**RB187-06/07
R602.10.1.1 (New), Figure R602.10.1.1 (New)**

R602.10.1.1 (New), R602.10.11.2, Figure R602.10.5(2)-(New)

R602.10.5, Figure R602.10.5(1)-(New)

**FIGURE R602.10.1.1
ANGLED CORNERS**

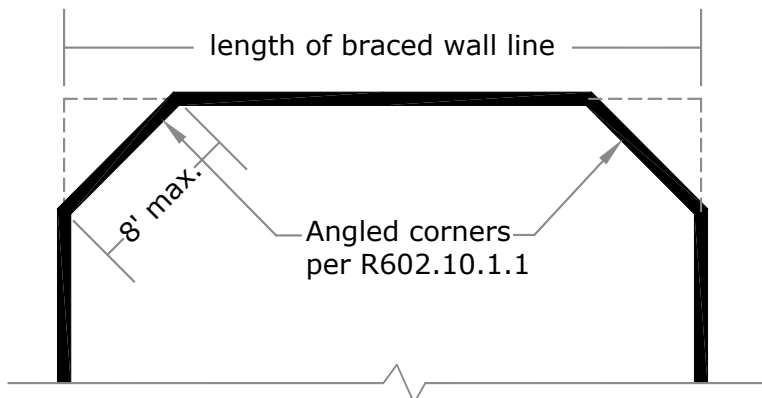
R602.10.1.1 Angled corners. At corners, braced wall lines shall be permitted to angle out of plane up to 45° with a maximum diagonal length of 8 feet. When determining the amount and location of bracing, the length of the braced wall line shall be determined using the in-line projection of the angled wall as shown in Figure R602.10.1.1. Where an angled corner is constructed at an angle equal to 45° and the diagonal length is no more than 8 feet (2438 mm) in length, the angled wall may be considered as part of either adjoining braced wall line. Where the diagonal length is greater than 8 feet (2438 mm), it shall be considered its own braced wall line and be braced in accordance with section R602.10.1 and methods in section R602.10.3.

The angled corner can take a component of the load being transferred along the braced wall line. The magnitude of this component varies with the angle created between the wall line and the corner. The greater the angle, the lower the magnitude of the load. For this reason the length of wall added to the braced wall line is equal to the projected length as shown in the figure, not the actual length. The eight foot maximum length is to stay consistent with the offset limits in R602.10.1.

**FIGURE R602.10.5(2)
ALTERNATE CORNER BRACING**

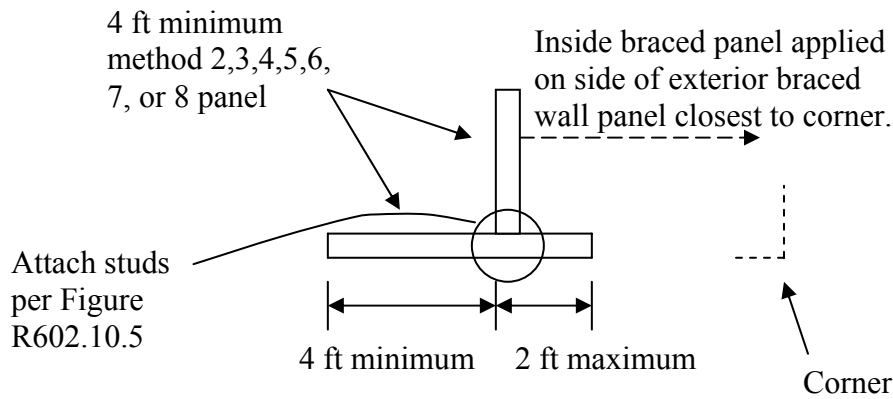
1. A minimum 24-inch-wide (610 mm) panel of method 3 construction is applied to each side of the building corner and the two 24-inch (610 mm) panels at the corner shall be attached to framing in accordance with Figure R602.10.5; or
2. The end of each braced wall panel closest to the corner shall have a tie-down device fastened to the stud at the edge of the braced wall panel closest to the corner and to the foundation or framing below. The tie-down device shall be capable of providing an uplift allowable design value of at least 1,800 pounds (8 kN). The tie-down device shall be installed in accordance with the manufacturer's recommendations.; or
3. A four foot long interior wall braced wall panel be attached to one of the exterior braced wall panels in the same braced wall line, per figure R602.10.5(2).

Reason: This proposal plugs a serious structural flaw in the current IRC provisions. It also provides a new structurally acceptable method to mitigate the effects of the main proposal.

The Canadian method tells us that as soon as we move the panel away from the corner, if we don't provide a holddown for it, it loses 2/3rds of its capacity. Overall, the braced wall line loses about half its capacity.

A new option has been added. The Canadian method shows us that it doesn't really matter which panels get the corners. We just need to be sure that one braced panel in a wall run has a left-hand corner, and another braced panel has a right hand corner.

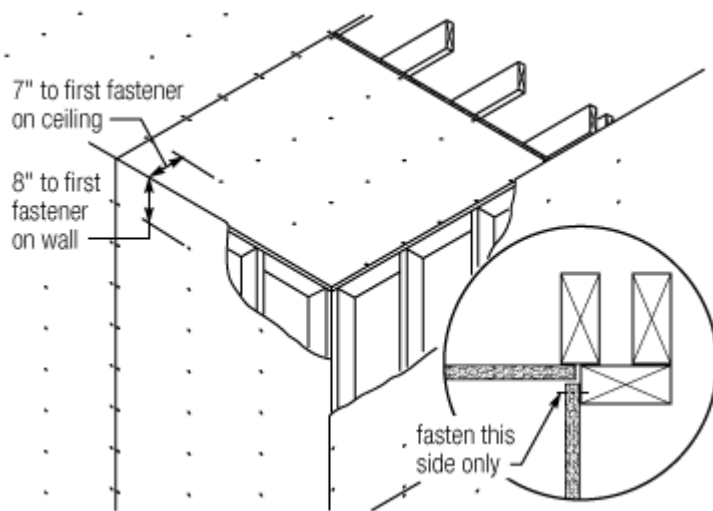
The WFCM and SSTD 10 do not depend on interior gyp that is not part of the explicit bracing system. They can also be used in a way that does not require any gypboard to act as bracing. As such, they warrant an exception. This provides a way for builders to take advantage of the gypboard industry's new recommendation to reduce cracking, without having to get engineering for their house design.

This is an illustration of the new gypboard nailing, taken from USG's website:

FIGURE R602.10.5(1) TYPICAL BRACED WALL LINE WITH CONTINUOUS STRUCTURAL PANEL SHEATHING

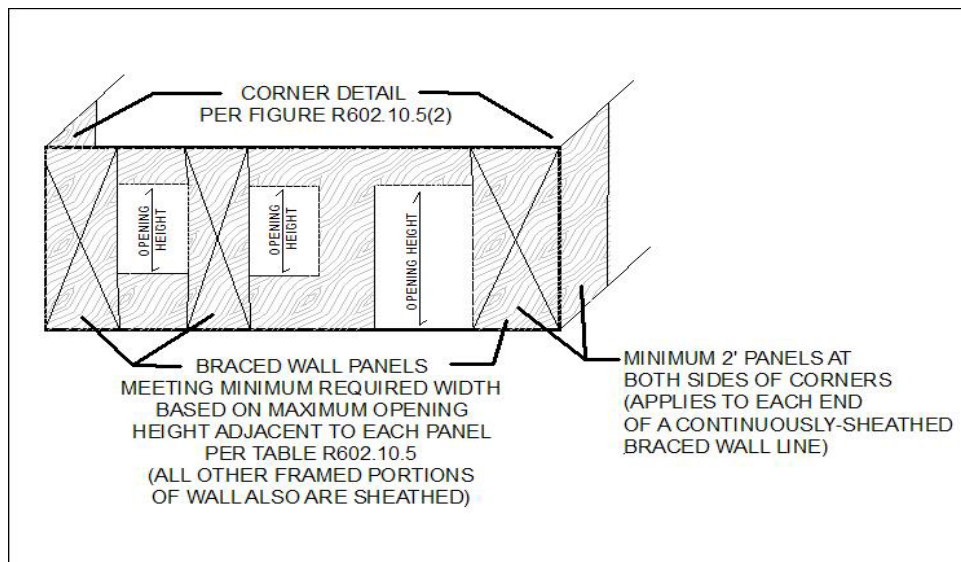
R602.10.5 Continuous structural panel sheathing. When continuous wood structural panel sheathing is provided in accordance with Method 3 of R602.10.3 on all sheathable areas of a braced wall line all exterior walls, and interior braced wall lines, where required, including areas above and below openings, braced wall panel lengths shall be in accordance with Table R602.10.5 and Figure R602.10.5(1). Wood structural panel sheathing shall be installed at corners in accordance with Figure R602.10.5(2). The bracing amounts in Table R602.10.1 for Method 3 shall be permitted to be multiplied by a factor of 0.9 for walls with a maximum opening height that does not exceed 85 percent of the wall height or a factor of 0.8 for walls with a maximum opening height that does not exceed 67 percent of the wall height. Other braced wall lines on the same story level or on different story levels of the building shall comply with any other approved bracing method. Different braced wall panel methods shall not be permitted within a given continuously-sheathed braced wall line.

1. Removes "all walls" requirement from Section R602.10.5
2. Allows use of other bracing methods on other braced wall lines (but not within a continuously sheathed braced wall line)
3. Adds a figure to illustrate a braced wall line with continuous structural panel sheathing
4. Clarifies that a minimum 2-foot corner return is required at ends of a continuously-sheathed braced wall line.
